Ministry of Northern Development, Mines, Natural  
Resources and Forestry

ERO Postings:  
No. 019-4363  
No. 019-4365

RE: Report ADM-2021-063 St. Marys Cement Inc. Canada – Proposed changes to the conditions of an ARA licence

SUBJECT: St. Marys Cement Inc. (Canada) - Changes to the conditions of a licence to operate a pit or quarry: ERO No. 019-4363 and ERO No. 019-4365

Drawing Number: 2 OF 3

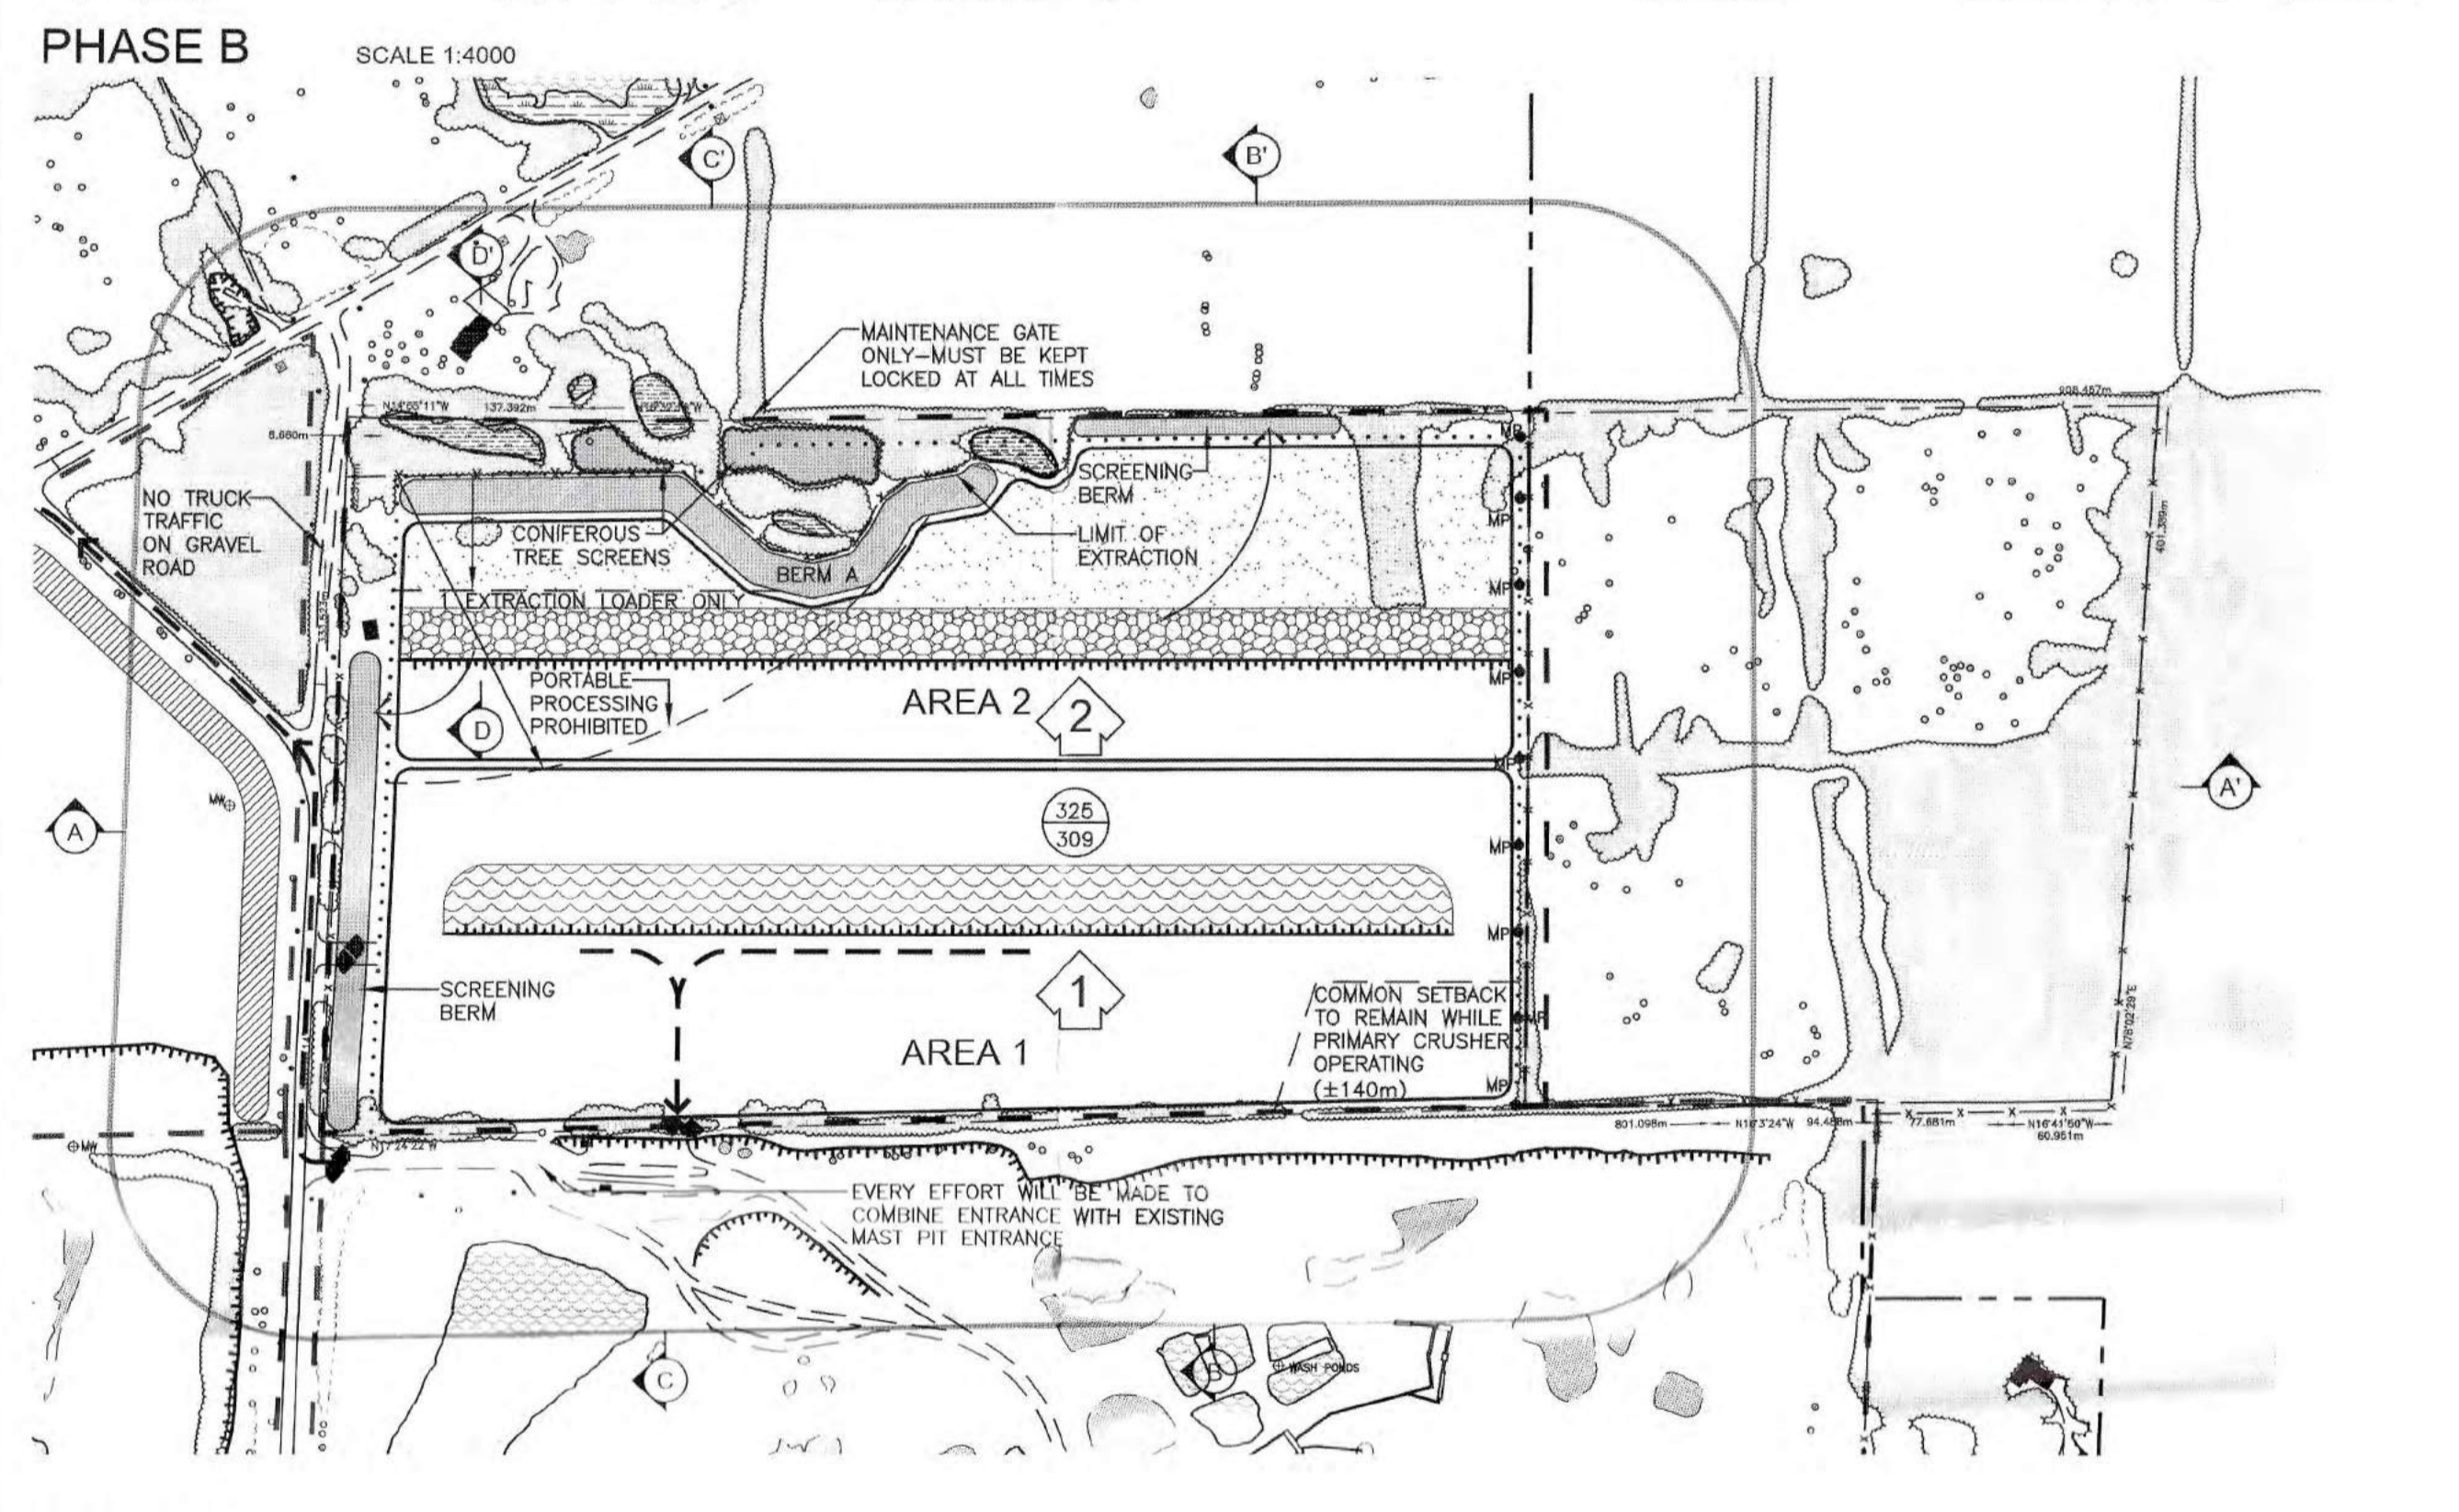
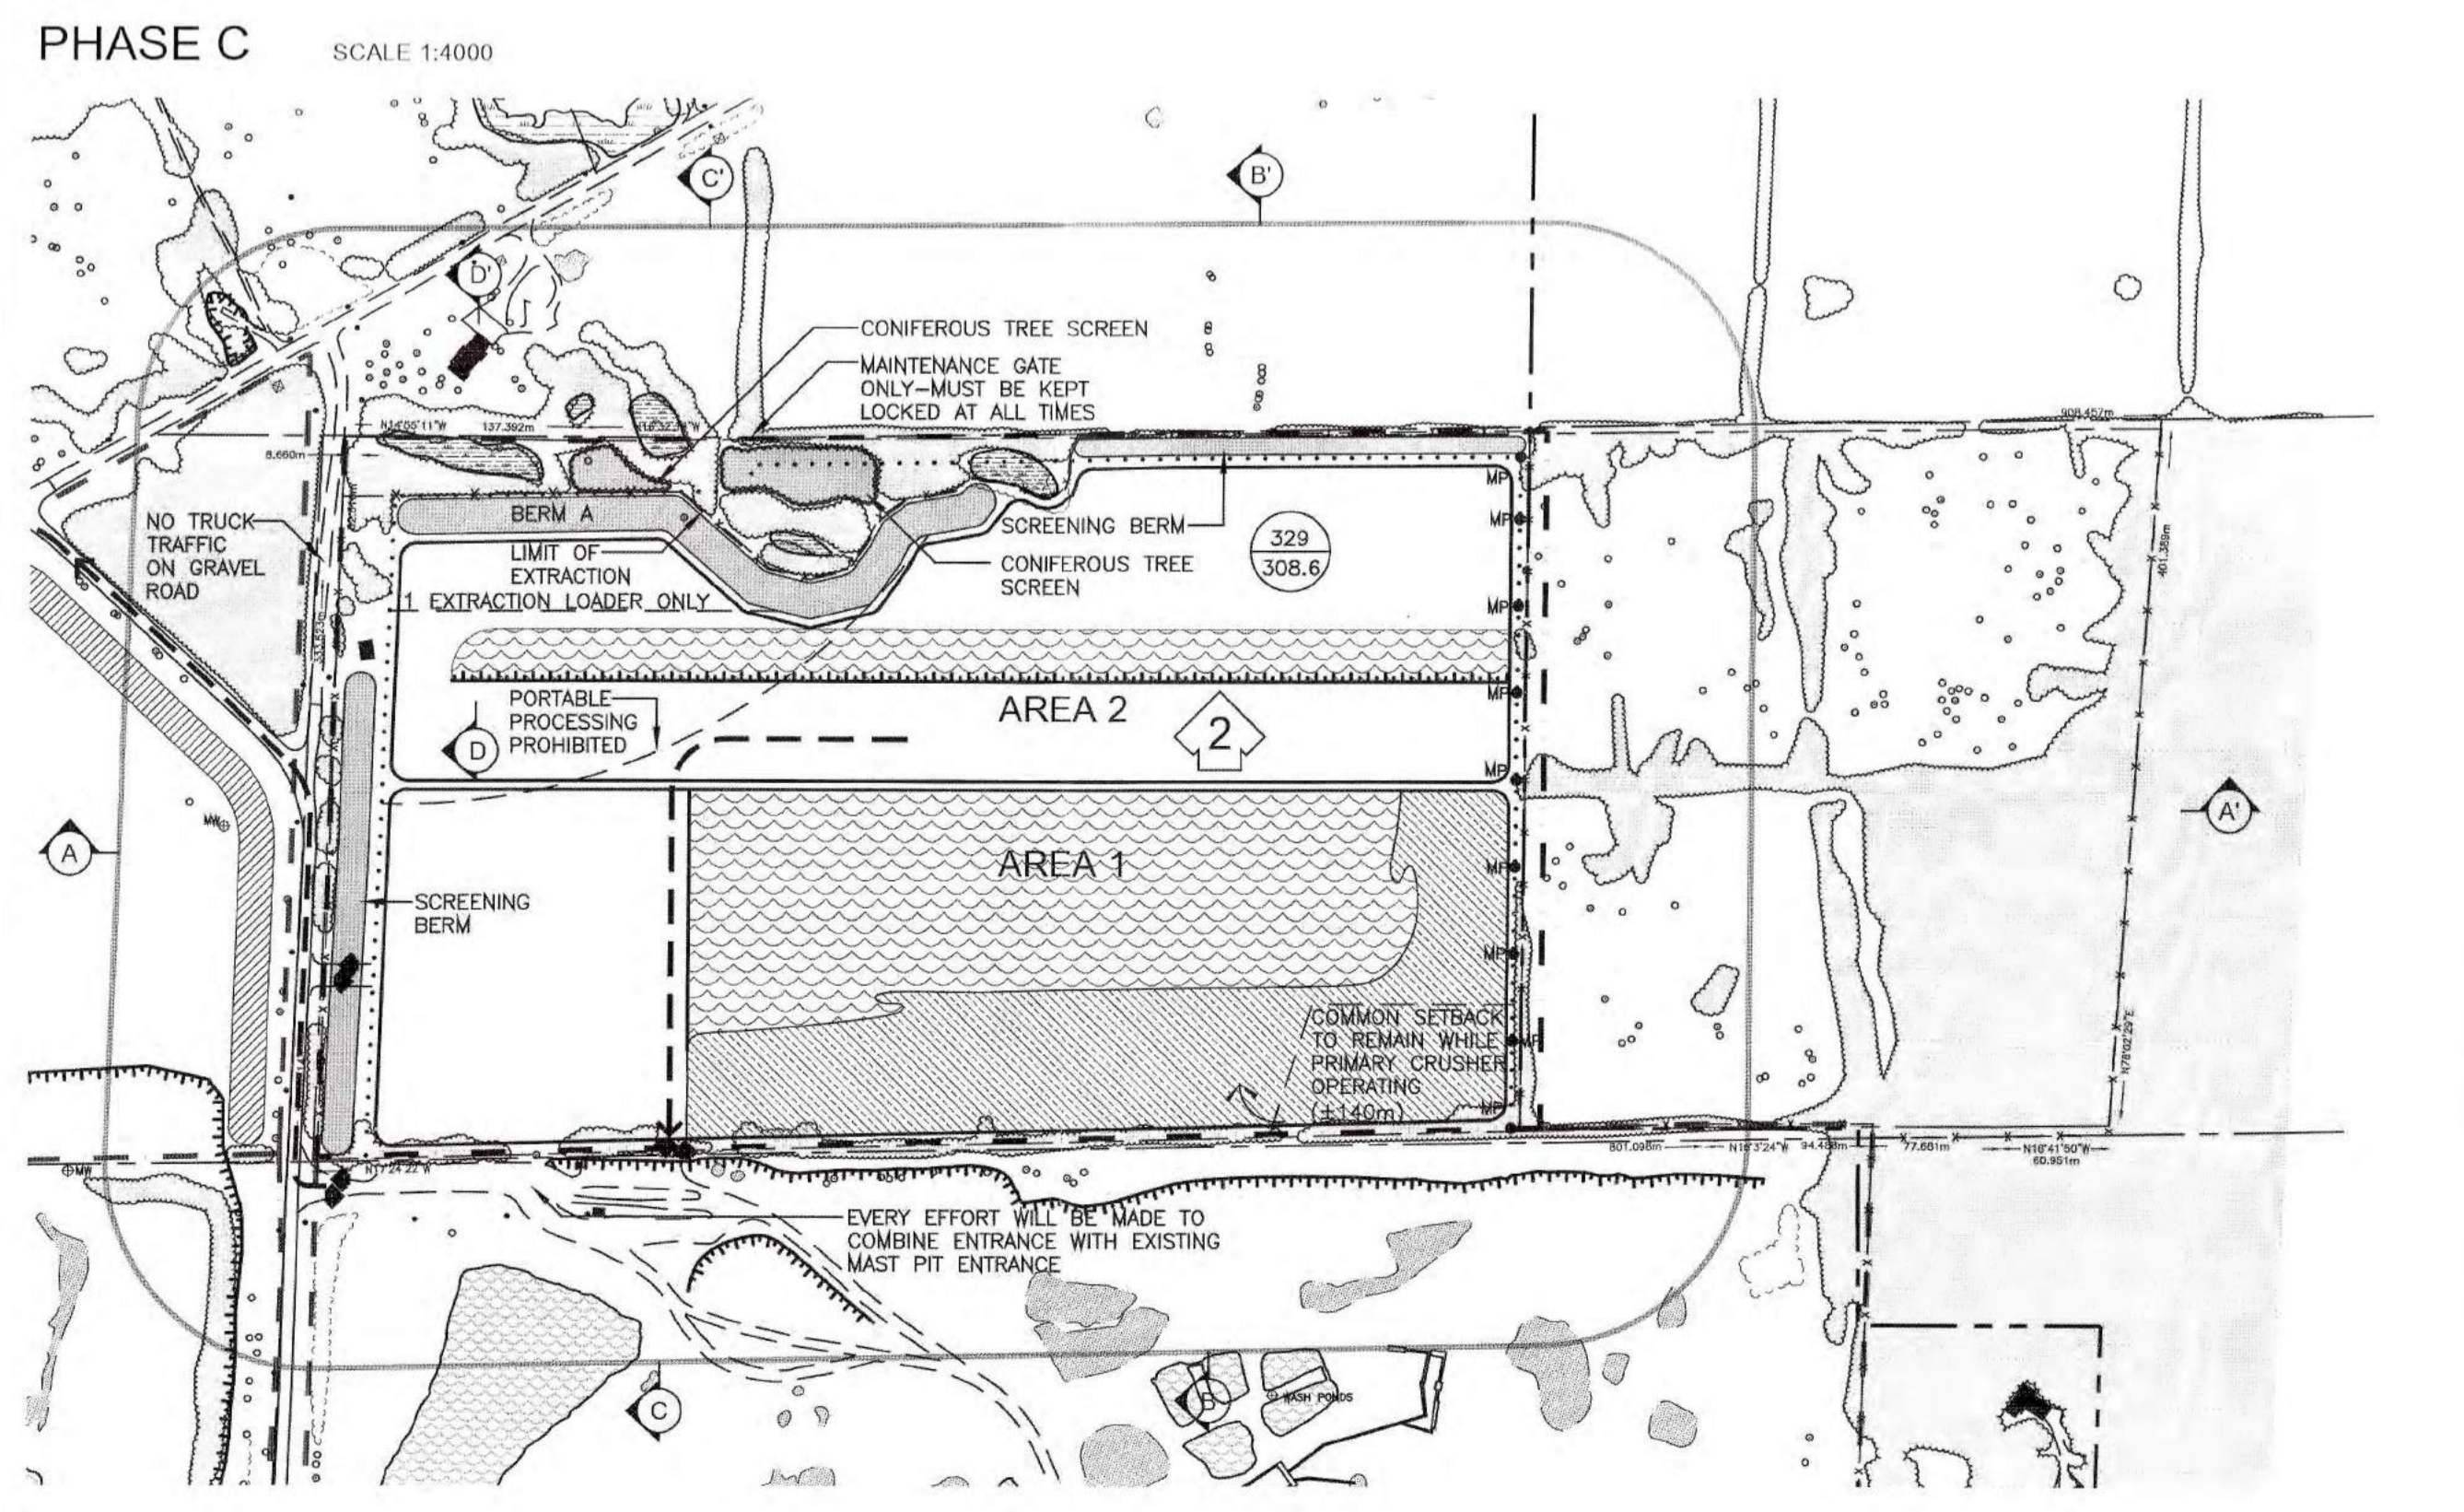
**Whereas material has exclusively been trucked across the road contrary to Note 13 on the Operational Plan; and**

A traffic study was completed as part of the OMB appeal. Staff reviewed the Neubauer Pit Operational Plan dated December 2011 (Plotted April 13, 2018) attached as Schedule "A" to this report. Note #13 on the Neubauer Pit Operational Plan makes reference to material haulage from the Neubauer pit going to either the McNally Pit or the Mast Pit via a conveyor under the existing municipal road. A copy of the note is included below:

*13. An Entrance/Exit has been proposed along Concession 2, this entrance will not be used for haulage of aggregate (refer to phase A note #1). At the present time it is intended that material will be moved from the property for processing at either the McNally Pit to the North or the Mast Pit to the West via conveyor under the existing municipal road (occasional processing at the face may occur and will be shipped via trucks using the Mast Pit Entrance/Exit). This will require additional studies and approval by the municipality which will be initiated once the license is issued.*

It is staff's understanding, that while the OMB decision notes, "transport material from the site by truck or conveyor under the municipal road, to either the neighbouring pit to the north or west, for processing", this was not the intent as stated in the operational plan that was subsequently approved in December 2011.

**That the Township of Puslinch does not support the proposed ERO No. 019-4363 and ERO No. 019-4365 unless St. Mary's Cement Inc. complies with the current Neubauer Pit Operational Plan dated December 2011 including the requirement that material will be moved under the municipal road via a conveyor; and**

**Either St. Mary's Cement Inc. constructs and operates a conveyor system to transport gravel under Concession 2;**

**Or satisfactorily demonstrates to the Province with a technical justification report that it is not technically and safely feasible to construct and operate such conveyor system; and**

**Where a conveyor system is determined not feasible by the technical justification report, that an underpass or overpass be established to truck material across the municipal road;**
